AS 5100.2:2017 Bridge design Part 2: Design loads

Amendment No. 2

Revised text amendment

FIGURE 7.2.3 A160 AXLE LOAD

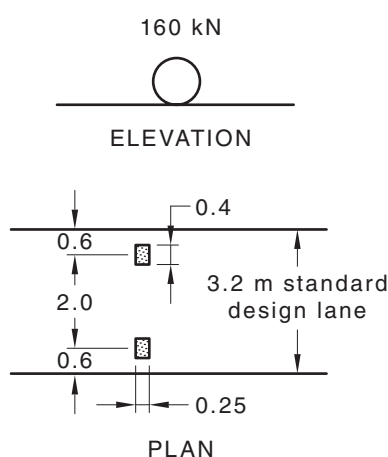
Element	Instruction/New text
	2 <i>Renumber</i> existing Items 9 to 21 to Items 11 to 23.
CI 6.4	At the end of the first paragraph, <i>add</i> the following: Variation in water levels shall be taken into account by using design levels based on a return period of 1 000 years for the ULS or 100 years for the SLS.
Tbl 6.4	<i>Delete</i> the note.
CI 6.5	Second paragraph, after “maximum amount”, <i>add</i> the following: , unless otherwise approved by the relevant authority
CI 7.2.3	<i>Delete</i> second paragraph and <i>replace</i> with the following: The A160 axle load shall be positioned within a 3.2 m standard design lane, as shown in Figure 7.2.3.
Fig 7.2.3	<i>Delete</i> figure and <i>replace</i> with the following:
